Title - Sujet Restauration de la Place George V Restauration de la Place George V, Québec (Québec)	
Solicitation No. - N° de l'invitation EE520-222036/A	Amendment No. - N° modif. 006
Client Reference No. - N° de référence du client R.094682.101	Date 2022-03-17
GETS Reference No. - N° de référence de SEAG PW-\$QCM-009-18288	
File No. - N° de dossier QCM-1-44166 (009)	CCC No./N° CCC - FMS No./N° VME
Solicitation Closes - L'invitation prend fin at - à 02:00 PM Eastern Daylight Saving Time EDT on - le 2022-03-24 Heure Avancée de l'Est HAE	
F.O.B. - F.A.B. Plant-Usine: <input type="checkbox"/> Destination: <input checked="" type="checkbox"/> Other-Autre: <input type="checkbox"/>	
Address Enquiries to: - Adresser toutes questions à: Thellend, François	Buyer Id - Id de l'acheteur qcm009
Telephone No. - N° de téléphone (418) 905-1853 ()	FAX No. - N° de FAX () -
Destination - of Goods, Services, and Construction: Destination - des biens, services et construction:

RESTORATION OF PLACE GEORGE V, QUEBEC CITY (QUEBEC)

AMENDMENT 006

The purpose of amendment 006 is to provide questions and answers 049 to 072.

QUESTION 66

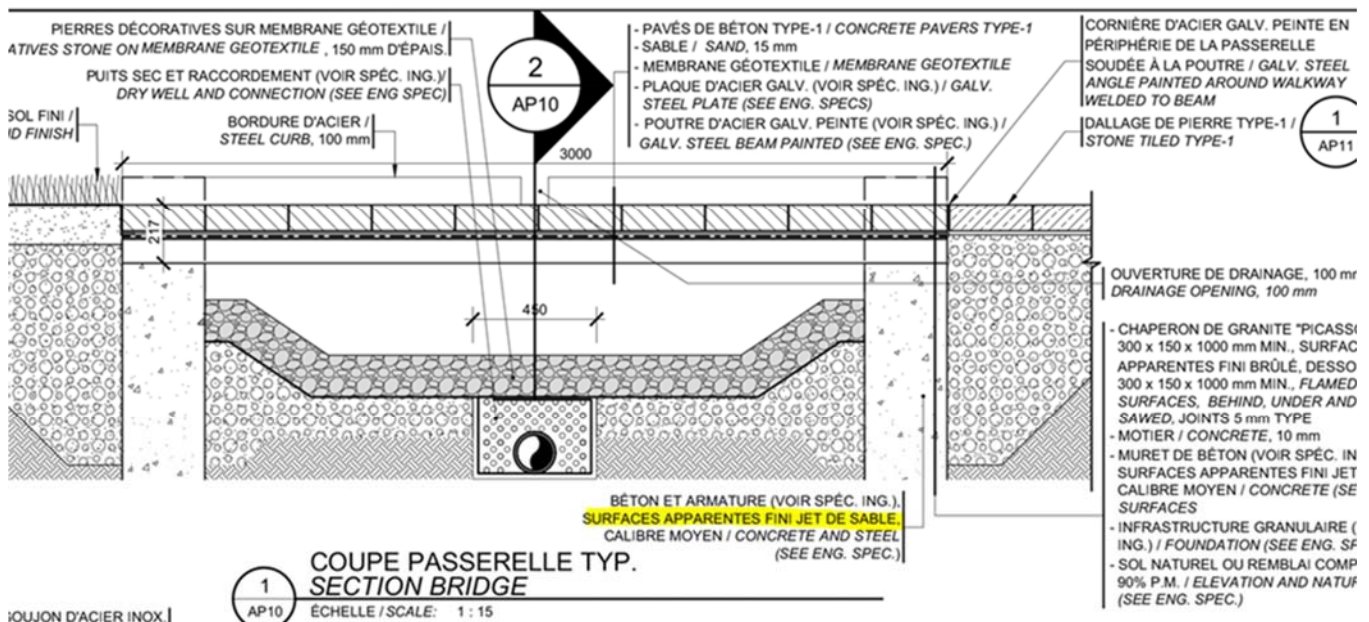
In section 1 of page AP10, a note indicates to finish the surfaces with a sandblast. Would it be possible to define/identify the surfaces that we must consider for a sandblast finish (like the staircase in the bedroom for example)?

All exposed surfaces, above ground, must be sandblasted. Example: the surfaces of the wall inside the ditch.

QUESTION 67

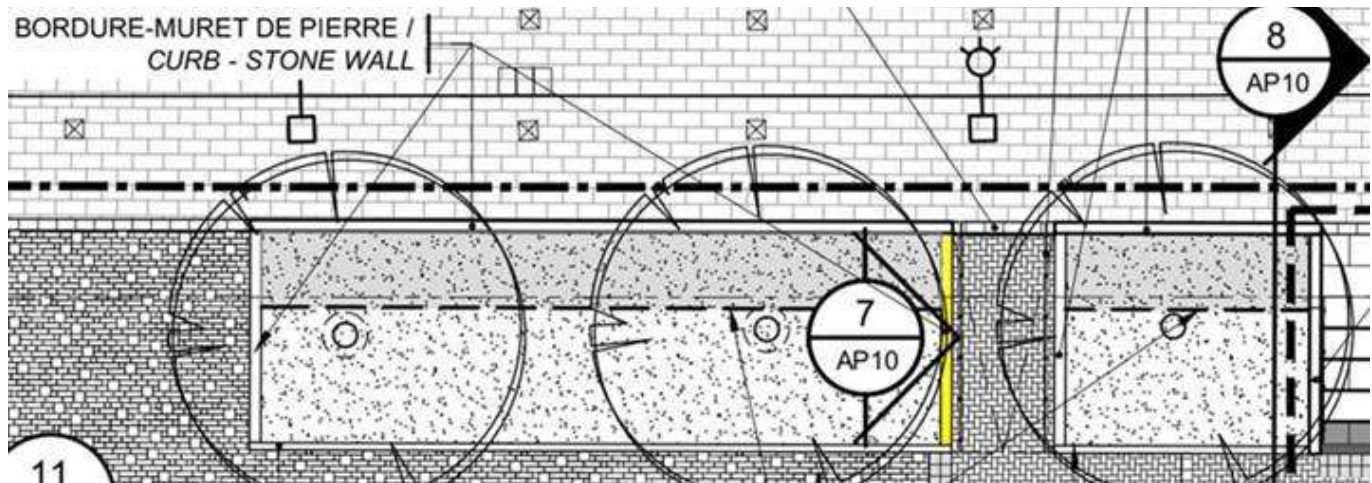
Following amendment 004 (question/answer 23 and addendum S-01), are we to understand that the section in yellow is no longer at the edge of the wall?

No, the sections on each side of the ramp, including the one identified in yellow, are curb walls.
